MEMORANDUM FOR: Zoltan R. Rosztoczy, Chief, Analysis Branch, DSS  
THRU: L.E. Phillips, Section Leader, Reactor Analysis Section,  
Analysis Branch, DSS *LEP*  
FROM: Wayne Hodges, Reactor Analysis Section, Analysis Branch, DSS  
SUBJECT: SUMMARY OF MEETING WITH GENERAL ELECTRIC

### Summary of May 24, 1979 Meeting With General Electric

ECCS MODEL ISSUES - EXECUTIVE OVERVIEW

PRESSURE DROP ACROSS STEAM SEPARATOR FOR  
AVERAGE POWER TESTS

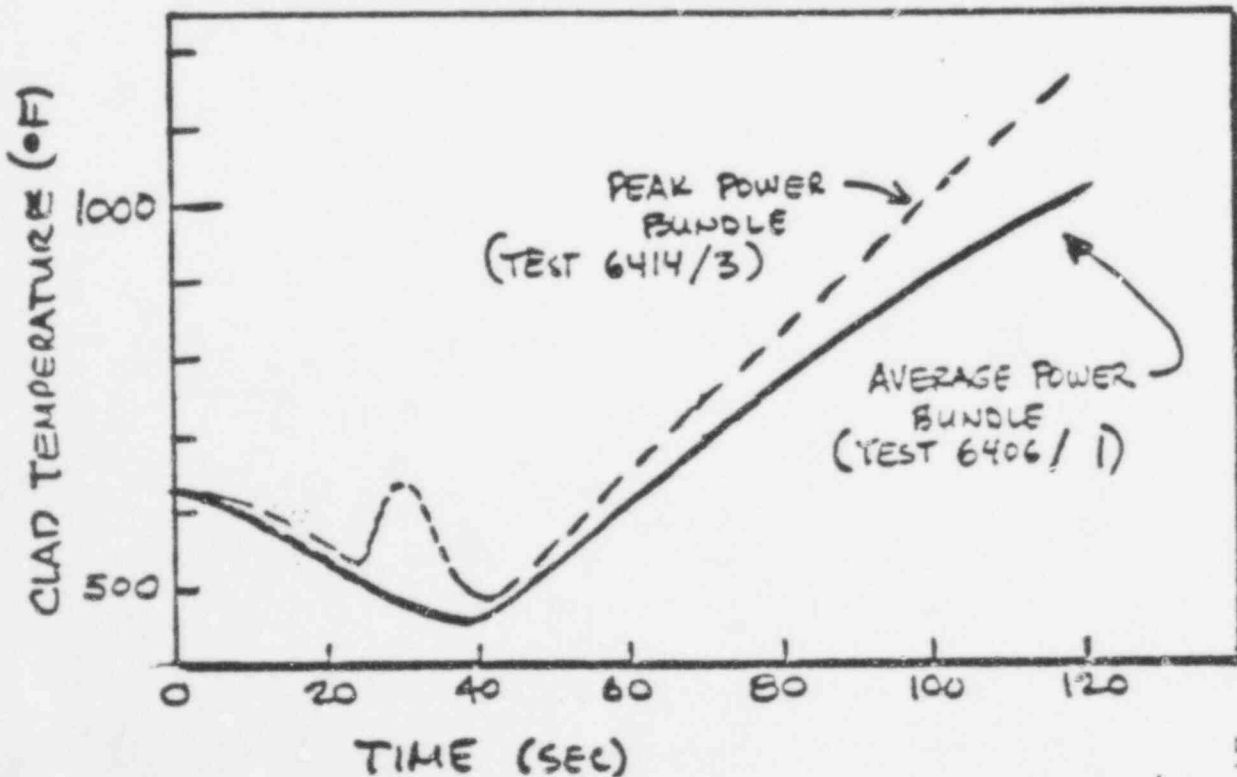
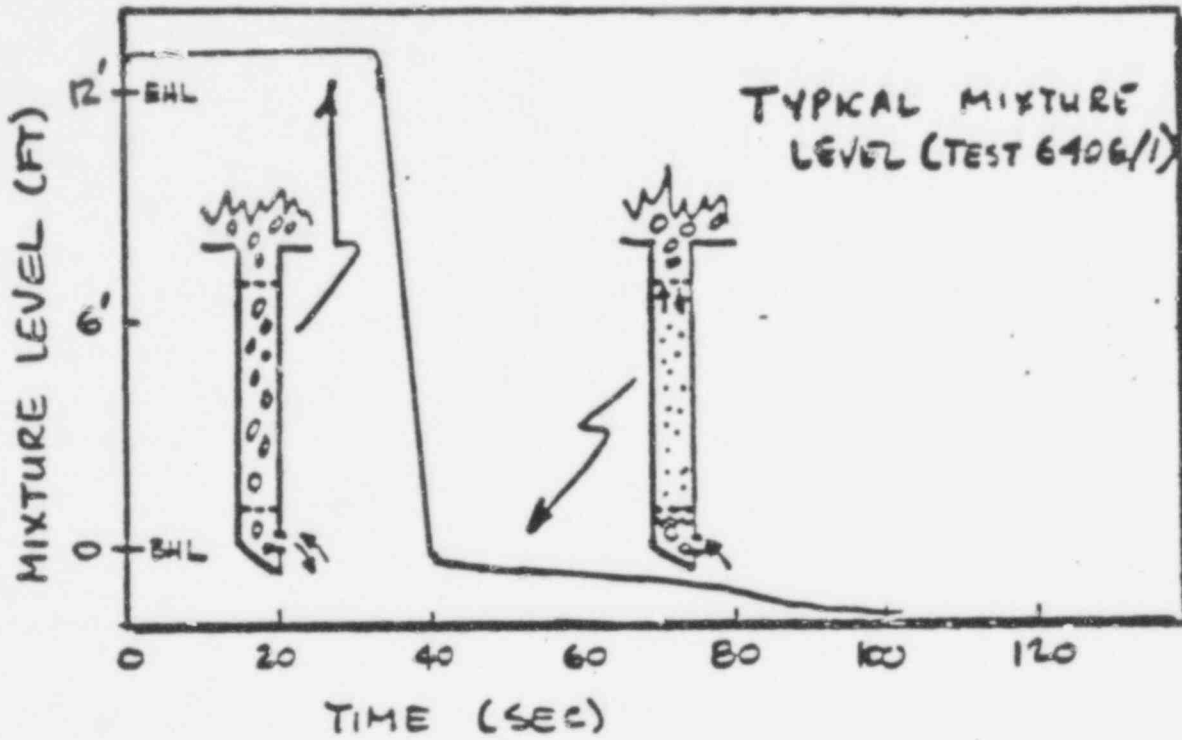
2. GE should strengthen the evidence that the steam separator  $\Delta P$  is a positive indication that the core region contributed less steam with ECC and that the slower depressurization was controlled by increased liquid break flow.

FIGURE 1 TEST WITH ECC MEASURED AND EM CALCULATED PCT

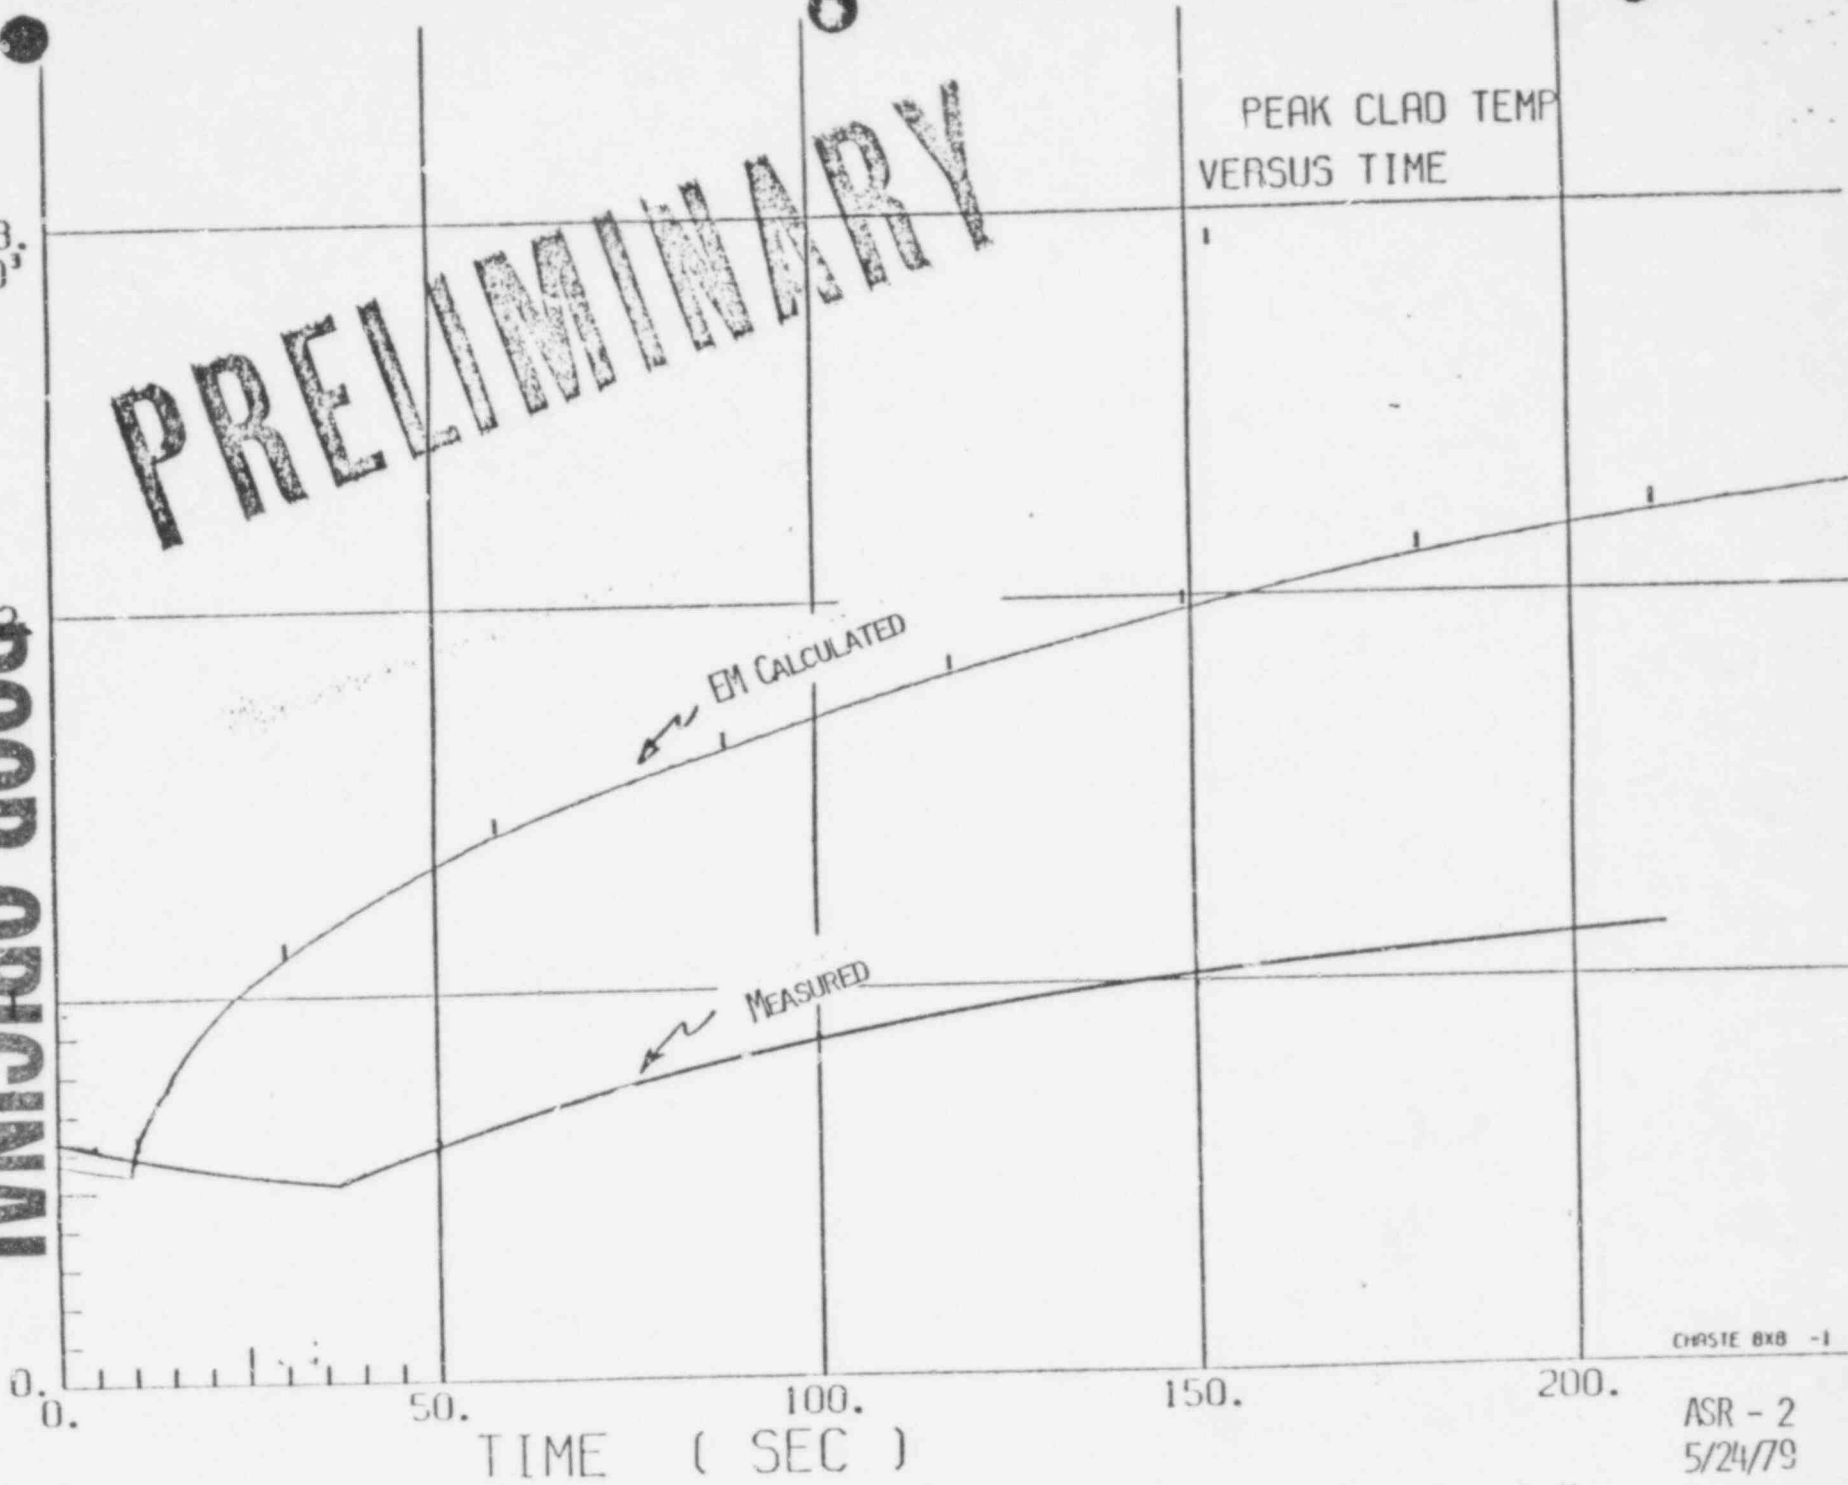
Based on this new interpretation of the TLTA data, GE concluded that the information requested in reference [redacted] no longer needed. As an alternative, GE proposed to submit a comparison of the peak cladding temperature as calculated by the evaluation model and as measured in the test for two

TLTA tests (average power, average ECCS flow and average power, no ECCS flow). The GE argument is that this comparison shows significant conservatism in the overall calculation (approximately 1000°F) and thus no detailed evaluation of submodels within the evaluation model is required.
